# SERVICE BULLETIN REVISION NOTICE

ENGINE — HP TURBINE ROTOR ASSEMBLY — INTRODUCE NEW FIRST STAGE TURBINE  
BLADES AND STAGE 1 HPT COOLING DUCT ASSEMBLY WITH DECREASED FLOW

Turbojet Engine Service Bulletin No. V2500-ENG-72-0475 Revision No. 3 dated May 7, 2019.

Revision 3 dated May 7, 2019

HPT DUCT REOPERATION PN 2A3487-01 TO PN 2A3914-01 (PART II)  
FIGURE 3, SHEET 1

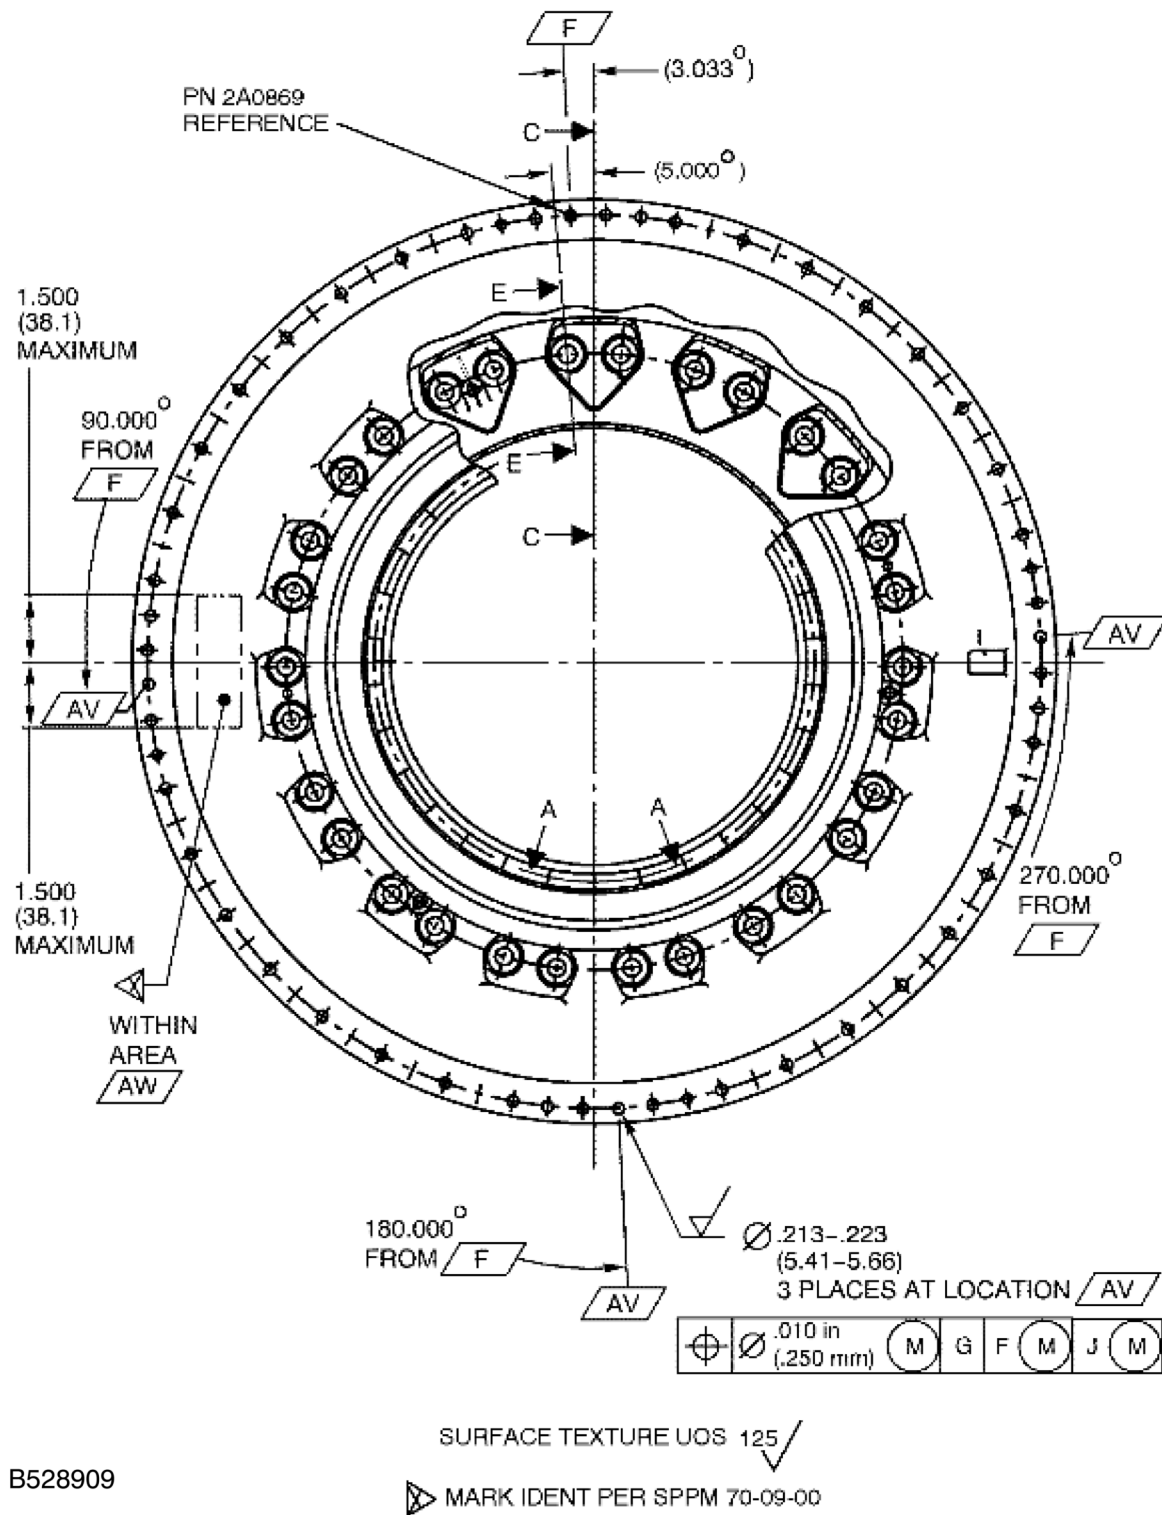
- A. Do a modification of the 2A3418-01 Stage 1 High Pressure Turbine (HPT) Duct Assembly (1 off). See Reference 4 or 5, 72-44-50 Figure/Item No. 01-010.
        - (1) Set-up and machine 3 holes 0.213 - 0.223 in (5.41 - 5.66 mm) diameter. Refer to Figure 3 (Sheets 1-5).
        - (2) Inspect and verify all dimensions in Figure 3 (Sheets 1-5).
        - (3) Do a modification to obtain the airflow level of 2A3914-01. Use the procedure given in Engine Manual TASK 72-44-50-300-010. Refer to Reference 4 or 5, Chapter/Section 72-44-50, Repair, VRS 3177.
          - (a) Minimum Pressure Ratio is 1.515.
          - (b) Maximum Pressure Ratio is 1.555.
          - (c) Flow Parameter is 1.066.
        - (4) Add plug welds as necessary by the procedure specified in Engine Manual TASK 72-44-50-300-010. Refer to Reference 4 or 5, Chapter/Section 72-44-50, Repair, VRS 3177.

- (6) Mark the new part number adjacent to the existing part number. Use the vibration peen method. Refer to Reference 1, Standard Practices/Processes Manual 70-09-00-400-501. See Reidentified Parts section for part numbers. See Figure 3 Sheet 1.

HPT DUCT REOPERATION PN 2A3487-01 TO PN 2A3914-01 (PART II)  
FIGURE 3, SHEET 3

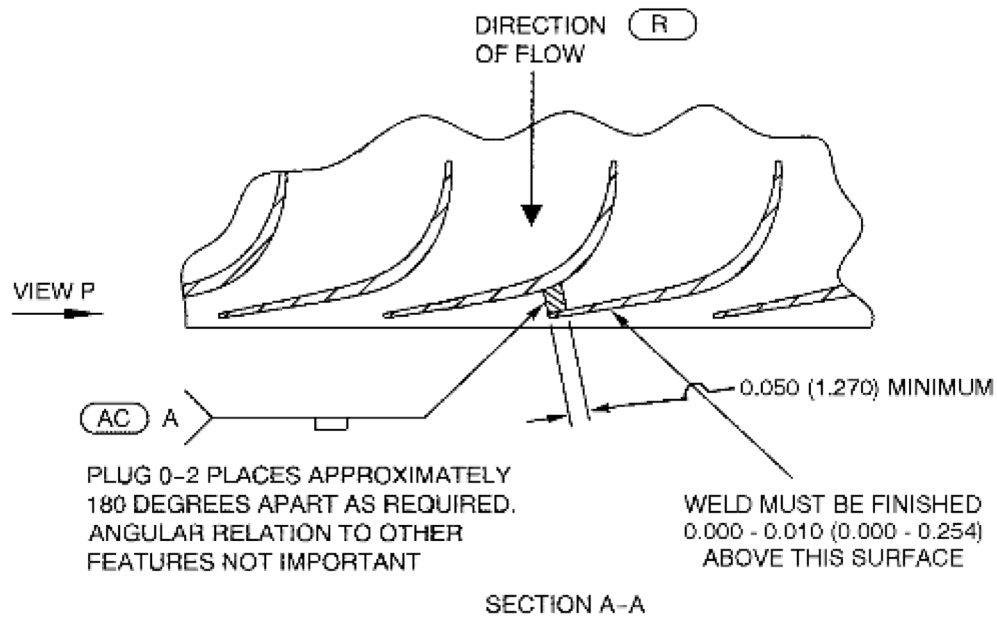
To revise Figure 3, Sheet 3 and Figure 4, Sheet 4 to update the weld specification.

(AC) WELD PER EM 72-44-50-300-010-REPAIR 010 (VRS3177)

HPT DUCT REOPERATION PN 2A3914-01 TO PN 2A3487-01 (PART III)  
FIGURE 4, SHEET 2

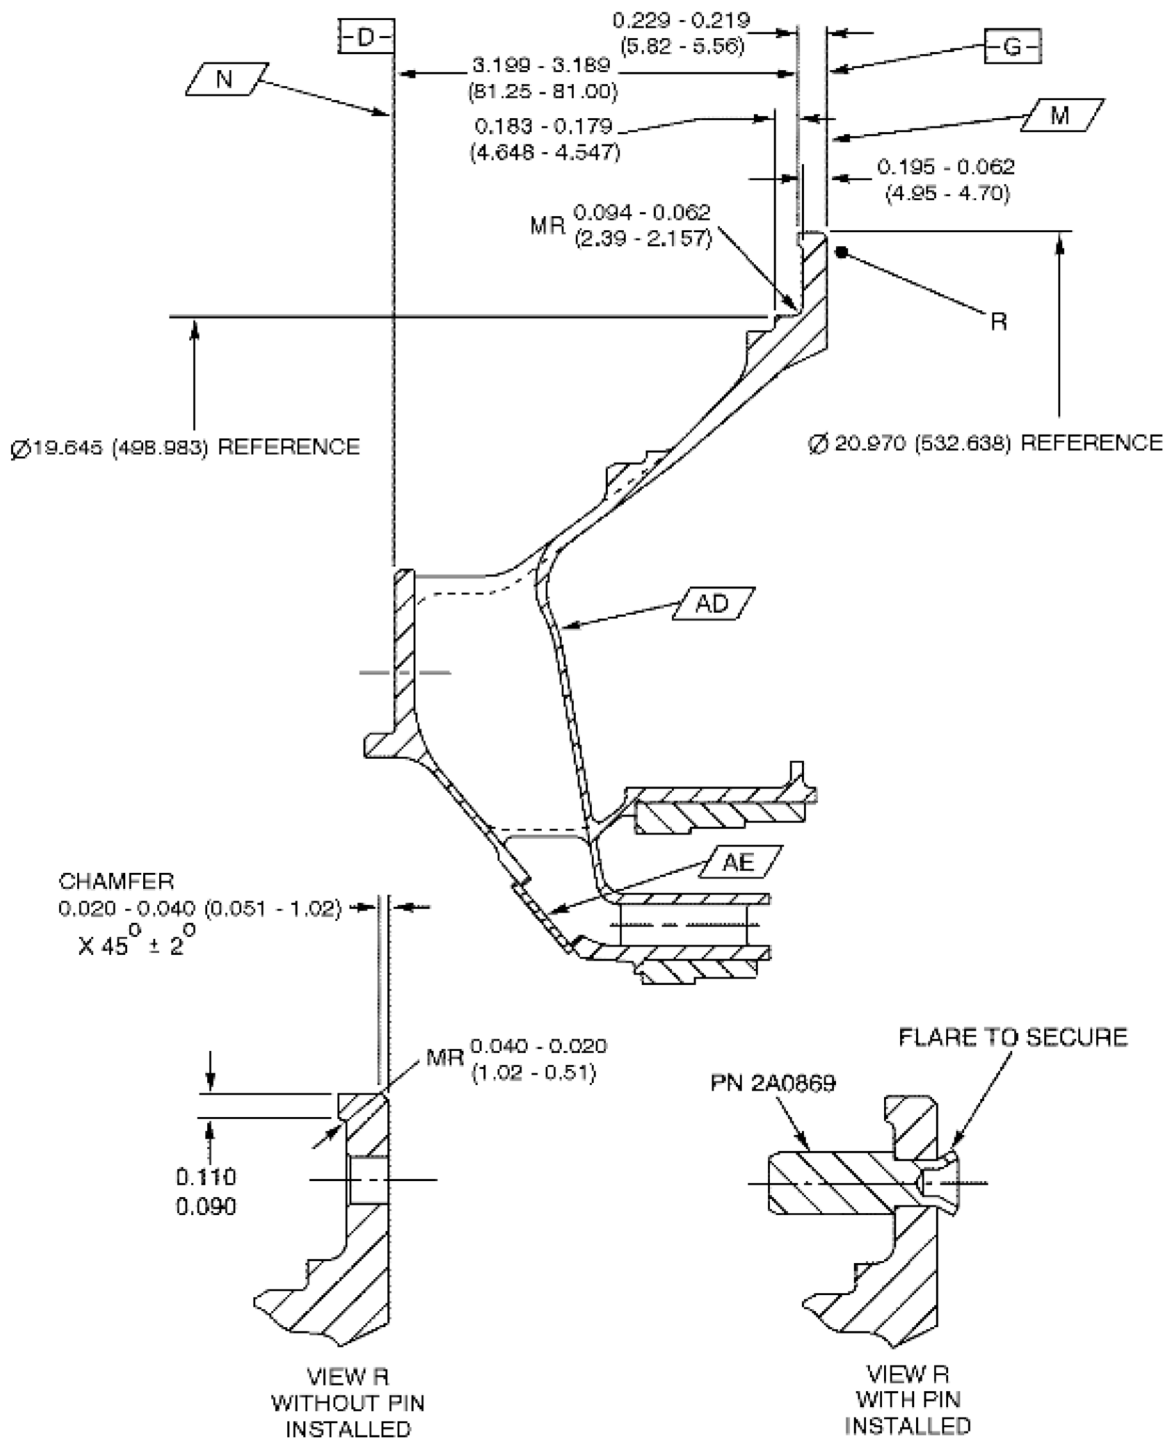
- C. Plug weld three (3) holes at location AV per Reference 1, Standard Practices/Processes Manual 70-31-13. See Figure 4 (Sheets 1-5).
- (1) Inspect and verify all dimensions in Figure 4 (Sheets 1-5).

- (4) Do a fluorescent penetrant inspection by the procedure specified in Reference 1, Standard Practices/Processes Manual 70-23-03-230-501. No cracks are permitted. Refer to Figure 4 (Sheets 1-5). Refer to the approved procedure in Reference 1, Chapter/Section 70-23-03 Fluorescent Penetrant Inspection.

- (a) Minimum Pressure Ratio is 1.508.
    - (b) Maximum Pressure Ratio is 1.558.
    - (c) Flow Parameter is 1.152.
  - (3) To achieve the required flow grind or machine the plug welds as necessary by the procedure specified in Engine Manual 72-44-50-300-010. Refer to Reference 4 or 5, Chapter/Section 72-44-50, Repair, VRS 3177.
